**Administrative Order NSL - 9339**

**XTO Permian Operating, LLC [OGRID 373075]  
Brushy Draw 31 07 Federal Well No. 103H  
API No. 30-015-57197**

**Re: XTO Energy Inc.  
Request for Administrative Approval of Unorthodox Well Location**

**EXHIBIT  
B**

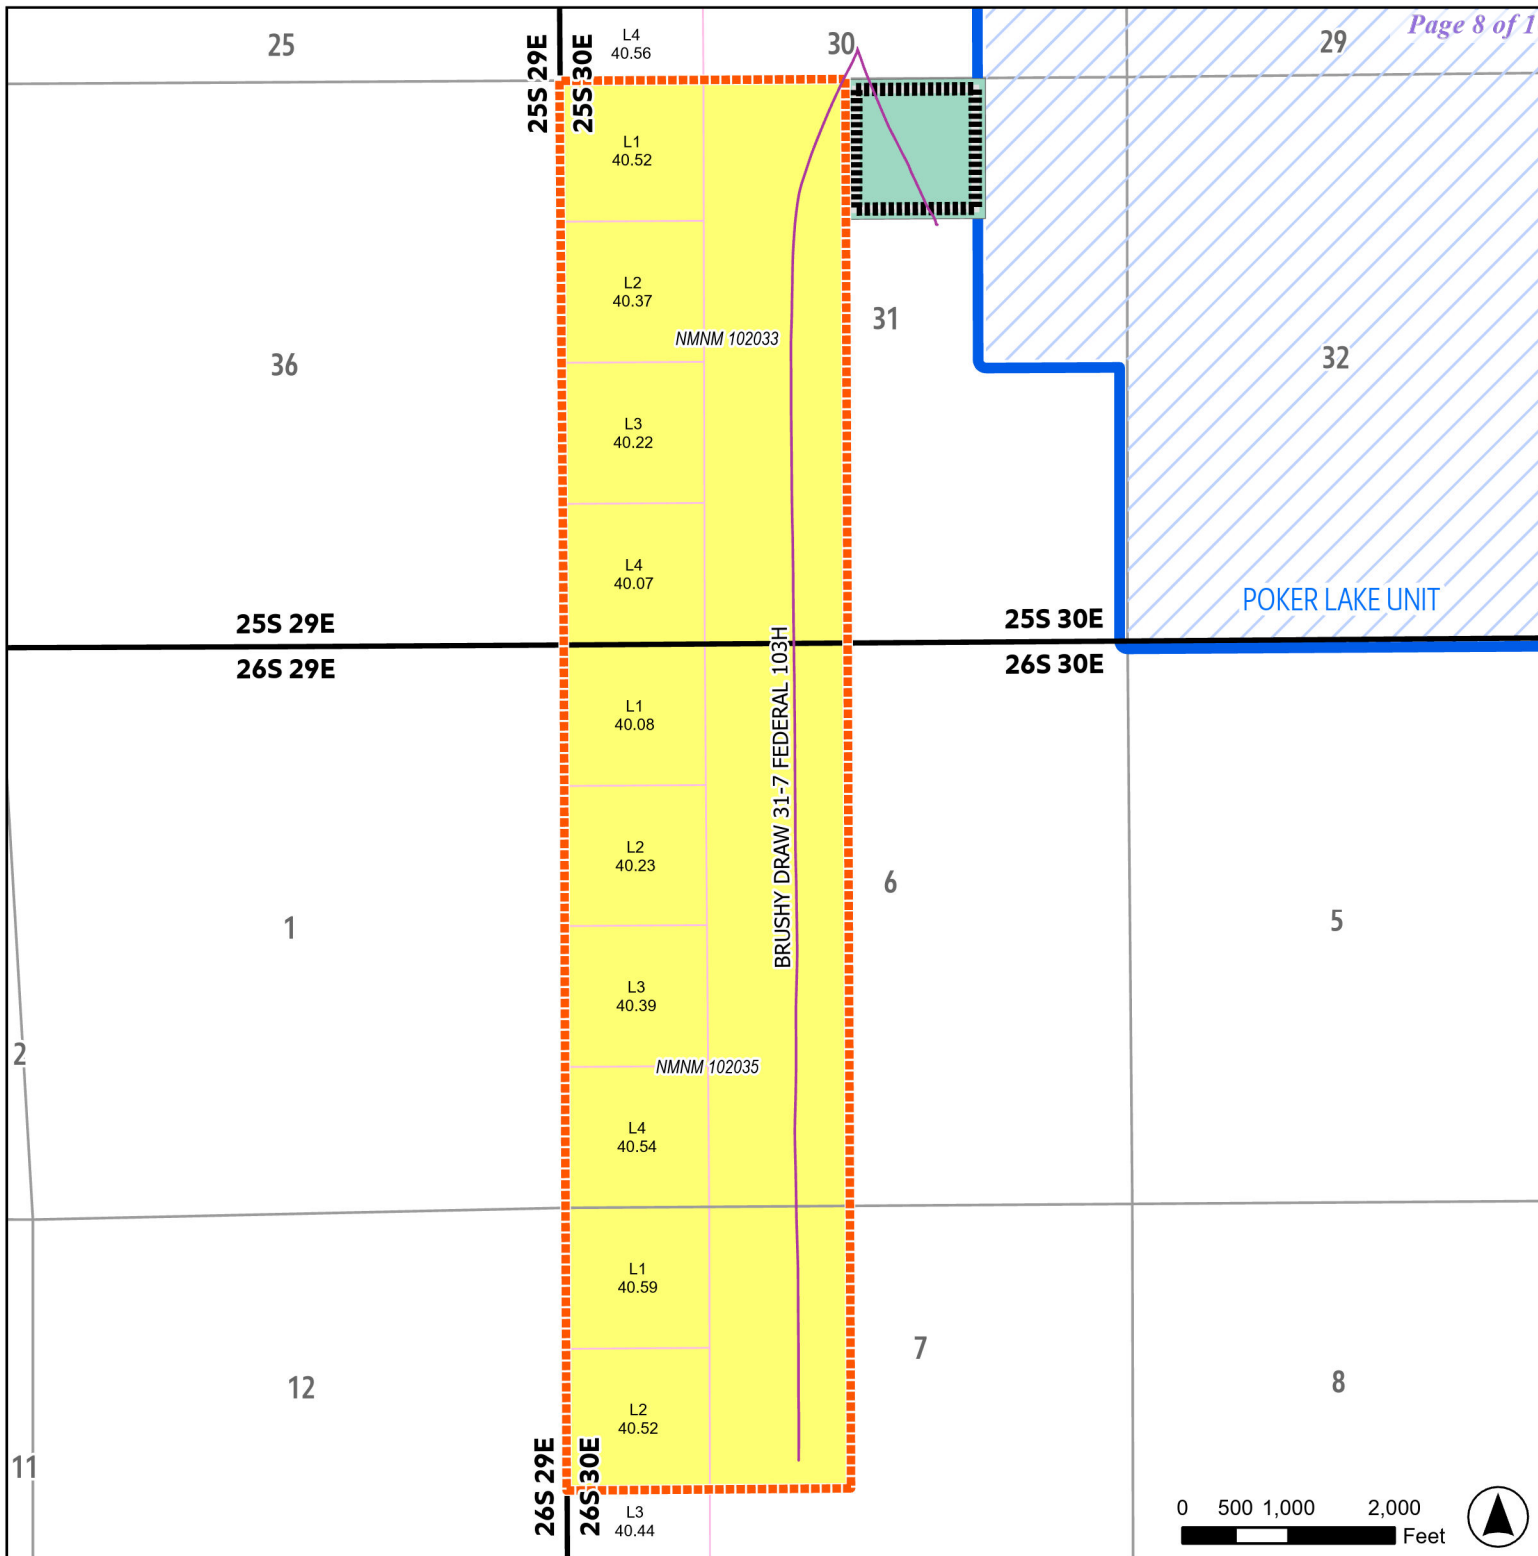
**Exhibit B** is a plat for the subject area that shows the Brushy Draw 31-7 Federal 103H well in relation to the offsetting tract, which is operated by XTO. The exhibit also identifies the other working interest owner in the offsetting adjoining tract, which is Chevron USA Inc. In addition, the exhibit identifies that the tract is part of a Bureau of Land Management (“BLM”) lease. Accordingly, the “affected persons”<sup>1</sup> are Chevron and BLM.

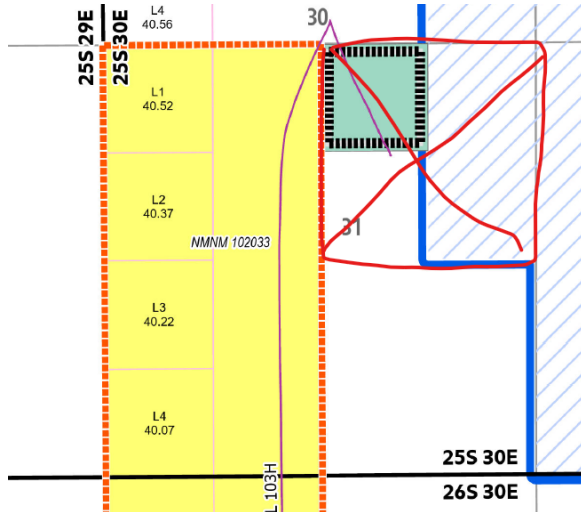
1. According to the application, is the FTP the location of the NSL distance? **Correct.**
2. The Purple Sage; W.C. pool requirement for notice towards the encroaching area should be 160 acres (QTR) of the affected tracts. According to your NSL application it only noticed the QTR – QTR section of the encroachment. Your notice is lacking. Unless you can state or prove that all you have noticed is also located in the QTR section of the encroachment section, if not then this application is lacking proper notification. **The parties for the QTR-QTR section are the same parties for the QTR section. Thus, all parties have been noticed (Chevron and BLM).**

The area with the red x should have been noticed.

3. Also, is the reason for the NSL the “preferred well spacing plan” or was there some other technical reason for this encroachment? **No technical reason. The request is based on XTO’s preferred well spacing for this particular area/spacing unit, which requires a slight encroachment at the kickoff.**
